P5027A-03-S

# Safety Service Note

## P5027A Keysight Streamline USB Vector Network Analyzer

“POTENTIAL BURN INJURY (HIGH TEMPERATURE) HAZARD”

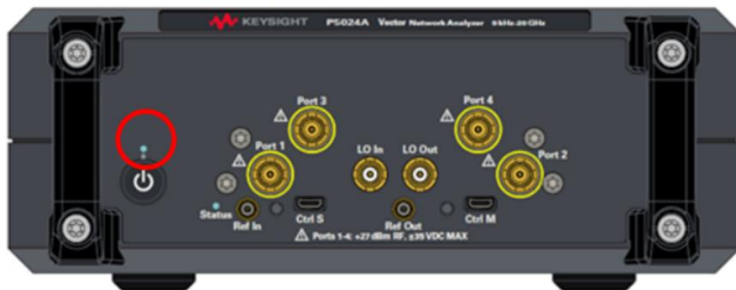
VNA fails to start with the following symptoms.

1. LED indicator (below circle) turns red.
2. cooling fan does not work
3. If user leaves the VNA with this LED indicator red without turning off power switch, it continues to overheat and becomes too hot.

Solution-1: Update VNA firmware by user

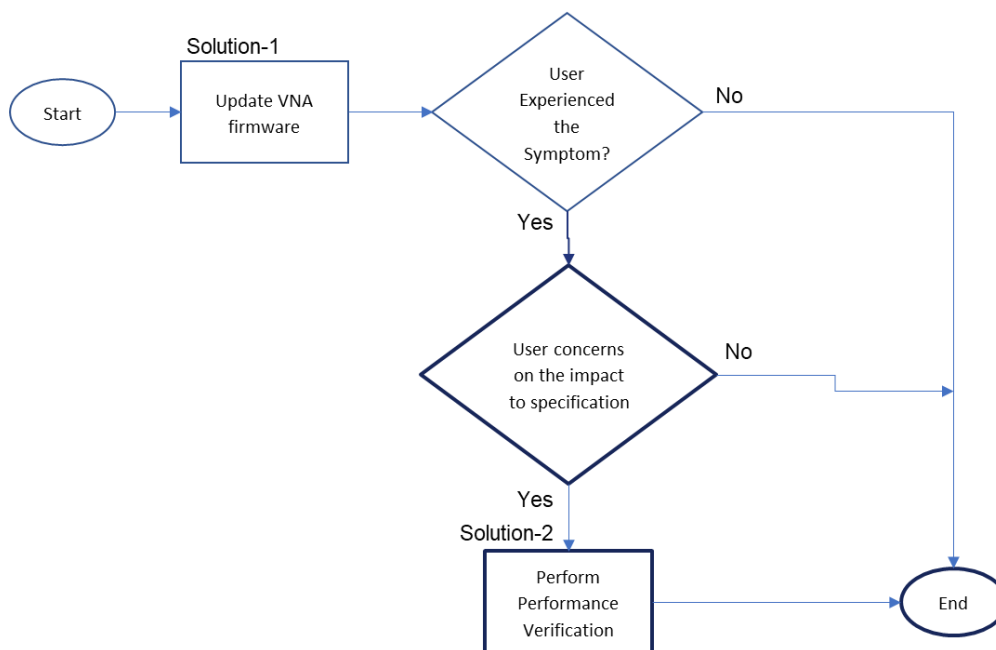
Potential presence of high temperature on front panel & chassis.  
Earlier versions of firmware have potential risk of overheating, due to thermal fan control malfunction.  
As a result, user may experience first degree epidermis burns on hand/ finger if in contact with the front panel & chassis.

**Action-1:** Updating the firmware eliminates this potential risk of overheating.

1. **Install the latest VNA firmware Rev. A.15.40.13 or newer** on users' controller PC(s).  
The latest firmware enhanced the thermal fan control mechanism.
2. Once the latest firmware is installed, proceed with the restart of both **controller PC** and **VNA**.
3. Launch the VNA firmware. Ensure VNA powers up and launches into firmware correctly after firmware update is done.
